This Service Information bulletin supersedes SI B13 04 09 **dated January 2011.**

N54 - Diagnosis of Cold Start Rough Running with Misfire Faults

E82, E88, E89, E90, E92, E93, E60, and E61 vehicles with the N54 engine produced up to 09/2008

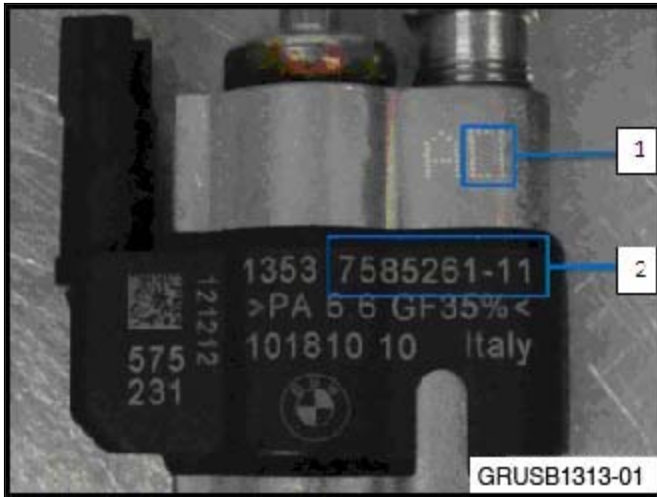
As of January 2013, an improved injector is available. Two distinct markings on the injector itself will identify the improved injector.

1 = Internal material improvement

2 = 7585261 – (index) 11 or greater

IMPORTANT: Injectors with index 11 and higher have a different calibration than injectors with index 10 and lower. Due to this difference, injectors with index 11 and higher and injectors with index 10 and lower cannot be used in the same engine.

If the misfire faults are stored, the complete set of injectors (6) needs to be installed using P/N 13 53 8 616 079 (index 11 or higher).

See the photo below to properly identify the index number.
